SUMMARIZATION OF NEW APPENDICES (B, C, D, E, F, G, H)

STATUS: *DRAFT FOR PUBLIC REVIEW — pending formal submission*

DATE: June 15, 2026

RE: Supplemental Public Comments and Risk Assessment regarding the Proposed 20 MGD Wastewater Treatment Facility

Exhibit C-1: 0.5-mile, 1.0-mile, and 2.0-mile rings centered on 3230 Mann Road, plotted on the TDEC Water Wells Desktop Application map. Each dark dot represents a permitted private water well in the TDEC database.

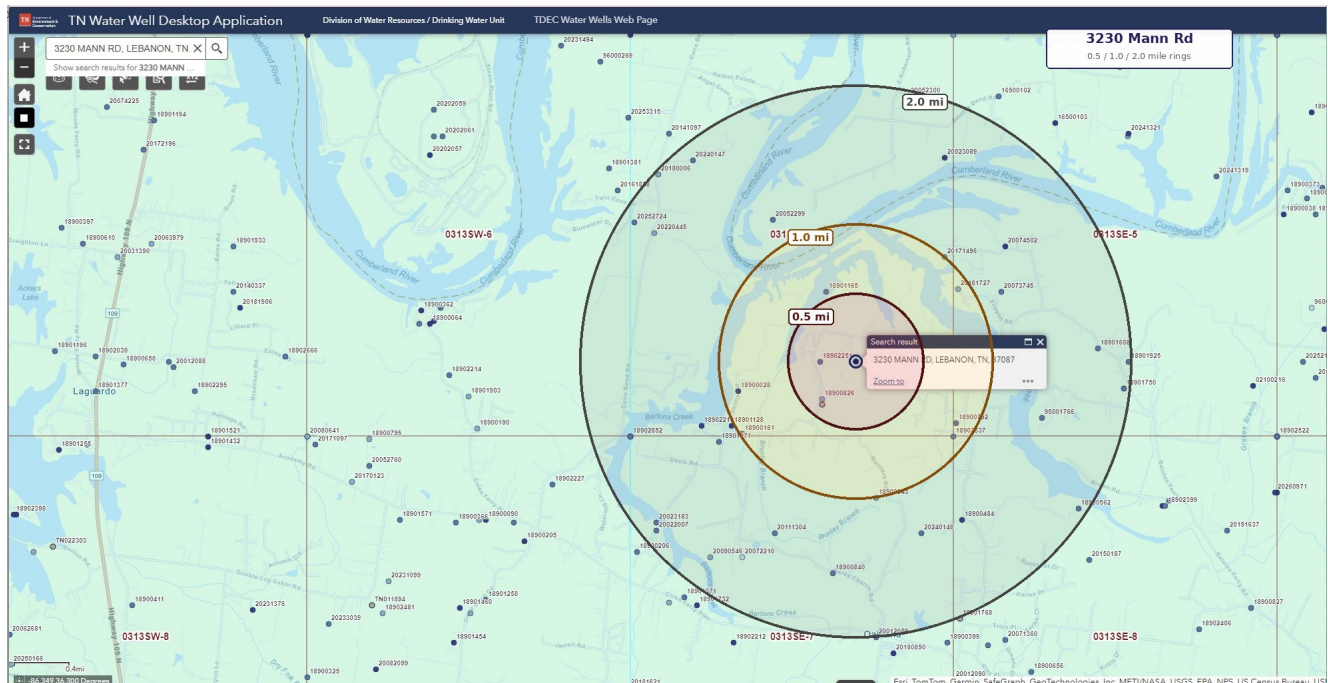
A query of the Tennessee Department of Environment and Conservation (TDEC) Water Well Locations public database identifies **a minimum of 38 permitted private wells within the 2-mile contamination radius** surrounding the proposed Mann Road and Berea Church Road footprint. Of these:

- **6 wells are located within 0.5 miles** of a proposed site, including a well at 1079 Berea Church Road (Coster) situated approximately 850 feet (0.16 mi) from the Mann Road site;
- **16 wells are located within 1.0 mile** of a proposed site;
- **38 wells are located within 2.0 miles** of a proposed site, the outer boundary of the karst contamination radius identified in Section VI.

The geographic distribution of these wells, with concentric 0.5-mile, 1.0-mile, and 2.0-mile rings, is depicted in Exhibit C-1 below. Recorded uses include residential drinking water (32 wells), agricultural and irrigation (9 wells), and geothermal heat pump (3 wells). The Site Selection Committee has not, to the petitioners' knowledge, entered these figures into the public record.

Important caveat: The figure of 38 wells is a minimum. The TDEC Water Well Locations database includes only those wells for which a licensed driller filed a report. Wells drilled prior to the

- Formally request a hydrogeological study from a qualified third party documenting (or refuting) hydraulic connectivity between the proposed site footprint and the LUD well field;
- Require coordination with the LaGuardo Utility District Board of Commissioners as a prerequisite to any further consideration of the Mann Road and Berea Church Road addresses;
- Enter the well-count data and accompanying ring map (Exhibit C-1) into the official public record of the site selection proceedings, and supplement it with an independent staff verification against the most current TDEC Water Well Locations database;
- Provide written notification to each identified well owner, and to all LUD ratepayers, of the proposed siting and the karst-aquifer contamination pathway described in Section VI of the principal statement.
